2018 Mercedes Benz E63S AMG 4MATIC Sed (213.089) V8-4.0L Turbo (177.980)

CHECK SEAT TRAVEL LIMITER AT SEAT FRAME BASE OF FRONT PASSENGER SEAT

Recall Campaign Bulletin

Campaign No. 2018090013, October 2018
Revision A

Figure 1

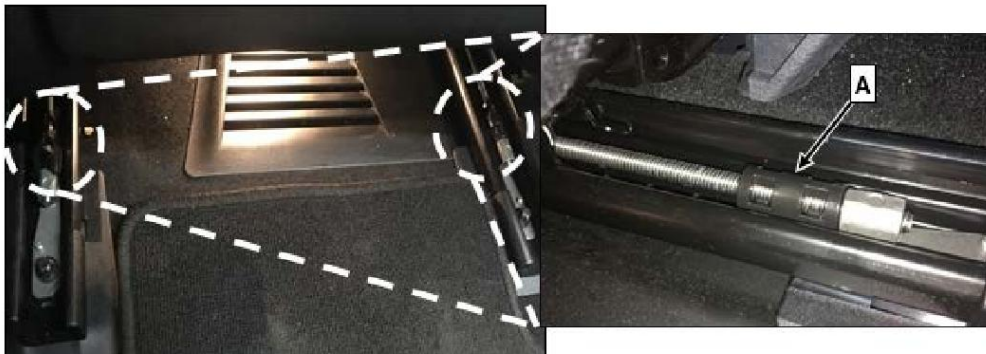
1. Check that seat travel limiter is present at front and rear of seat frame base of front passenger seat.
 - 1.1. Move front passenger seat to front-most position.
 - 1.2. Check for presence of seat travel limiter **(A)** (figure 1).

- a. Travel limiter **not** present: Perform **work procedure A and B**.
- b. Travel limiter **present**: Perform **work procedure B**.
